AMENDMENTS TO THE DRAWINGS

REMARKS

Application No. 10/805,670

Docket No.: V0195.0012

Figure 1f From The Present Application

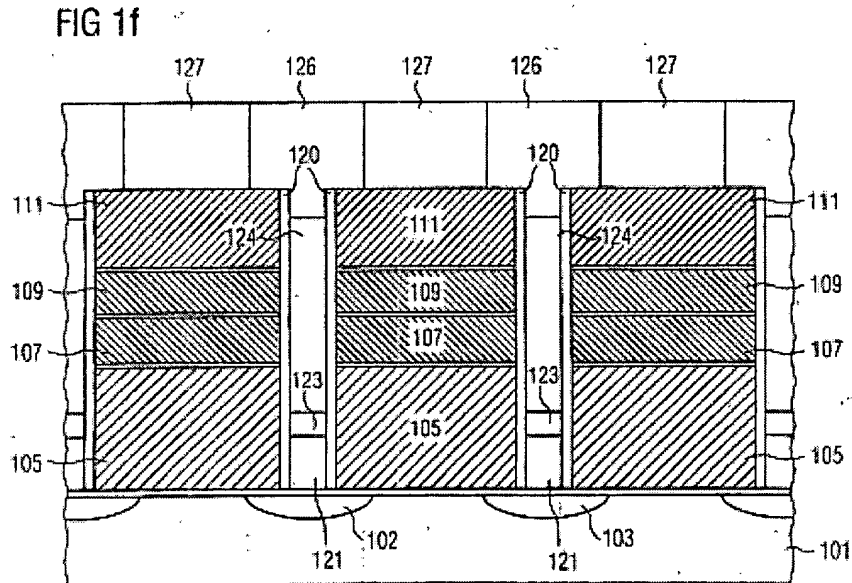
As disclosed in the present specification and shown for example in Fig. 1f, reproduced below, a floating gate 105 and multiple tunnel barrier layers 106-110 form the explicitly claimed layer system. Further, elements 121 and 124 are not shown in Noble. Specifically, as shown in Fig. 1f, electrode 123 is found adjacent to the floating

gate 105 and electrode 124 is found adjacent to the multiple tunnel barrier. This structure and the method for producing it is not taught or suggested in Noble.

FIG 1e

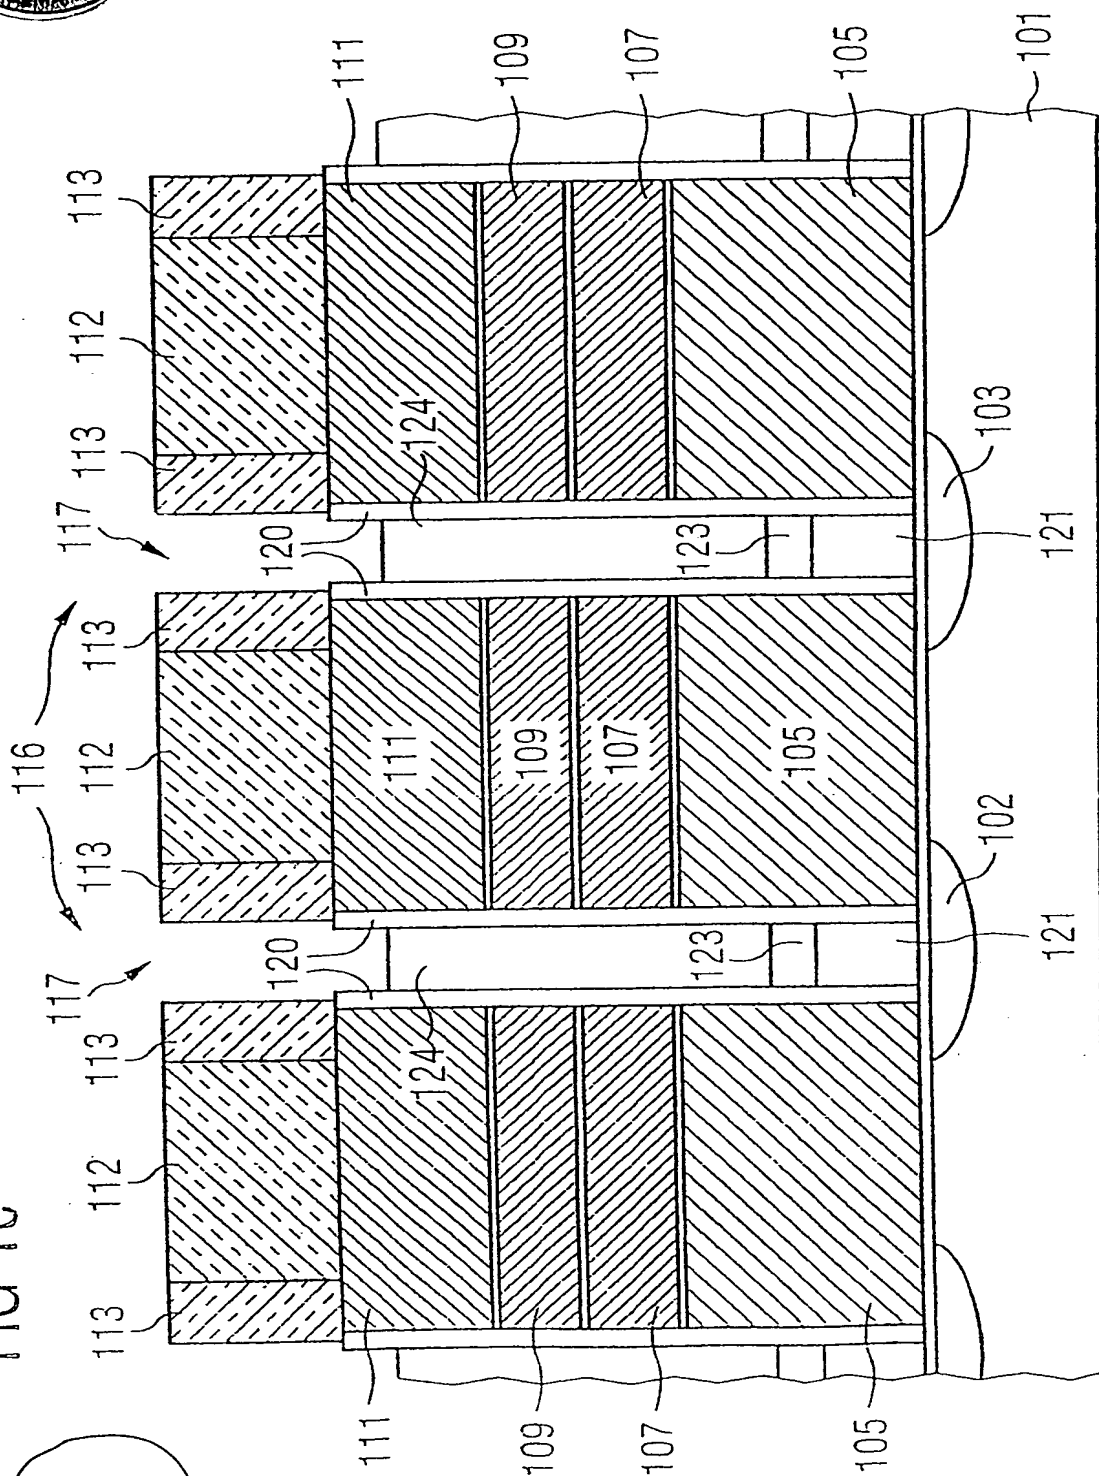
The Office Action objects to Figures 1e and 2e for not depicting the semiconductor memory element arrangement 100. Applicants have amended Figures 1e and 2e to show semiconductor memory element arrangement 100. Therefore, Applicants respectfully request reconsideration and withdrawal of this rejection.

The attached sheets of drawings includes changes to Figures 1e and 2e.
